REMARKS

The Drawings

Amendments to the Drawings:

FIG. 3

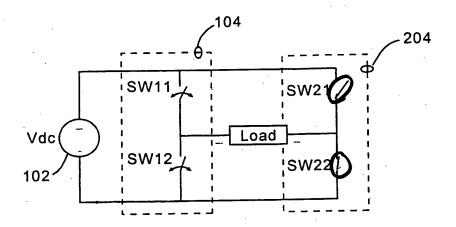
The drawings were objected to because of an error in Fig. 3. In particular, on page 7, lines 3-6 of the application, the circuit of Fig. 3 is described as being configured to produce a positive portion of the unipolar PWM output voltage signal, wherein the switch SW22 is maintained in a conducting state while switch SW21 is maintained in a non-conducting state. However, Fig. 3 as originally filed does not show such an arrangement. Thus, enclosed herewith for the Examiners' approval is a proposed correction of Fig. 3 that shows the correct switch arrangement with SW21 in a non-conducting state and SW22 in a conducting state. A second copy of Fig. 3 marked in red ink has also been enclosed to show the changes. Support for this amendment can be found on page 7, lines 3-6 of the application. No new matter has been added.

The attached sheet of drawings include changes to Fig. 3 on sheet 2 of 7. Also enclosed is a copy of sheet 2 of 7 containing Fig. 3 marked in red ink to show where the changes have been made.
